| REFERENCE:          | Nova Bus Manuals      |
| TC RECALL N°:       | 2013-412              |
| NHTSA RECALL N°:    | 13V-642               |

| SUBJECT:       | Sure Power DC-DC converter safety recall.   |

Figure 3 - N76239 DC-DC Converter

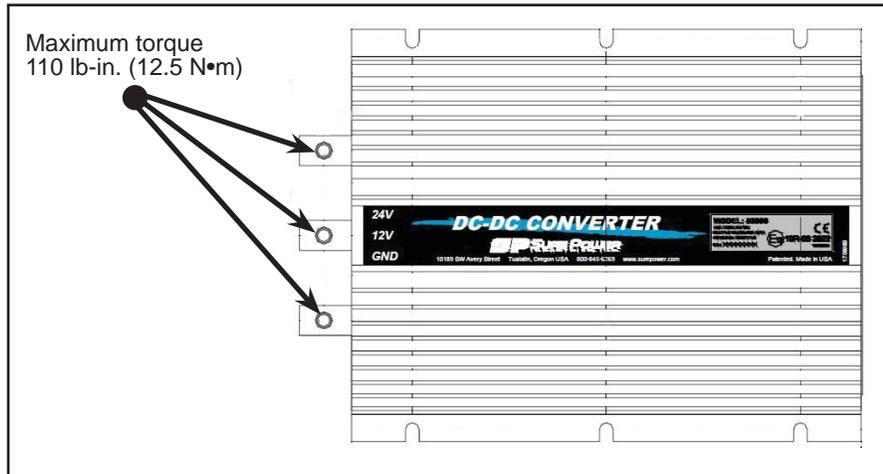
| JUSTIFICATION: | According to Sure Power, the specific potting compound used in a series of converters, as determined by the product manufacturer, is capable of conducting electricity once exposed to significant heat. The potting compound can melt and then burn, thus increasing the risk of fire. |

| LEVEL | DESCRIPTION                       | DIRECT CHARGES |          | TIME   |
|-------|-----------------------------------|----------------|----------|--------|
| 1     | Replace the two DC-DC converters. | Nova Bus       | Nova Bus | 60 min |

| QTY            | PART N° | REV. | DESCRIPTION         | REPLACES PART N° |
|----------------|---------|------|---------------------|------------------|
| 2              | N76239  | –    | 40A DC-DC converter | N35395           |

- 1.3. Identify the position of the three electrical cables connected to the converter (24V, 12V, GND).
- 1.4. Disconnect the converter's three electrical cables.
- 1.5. Remove the DC-DC converter. Retain the hardware.
- 1.6. Install the new converter N76239 using the retained hardware.
- 1.7. Install the three electrical cables according to their original position. Apply torque to the specified value. See Figure 2.
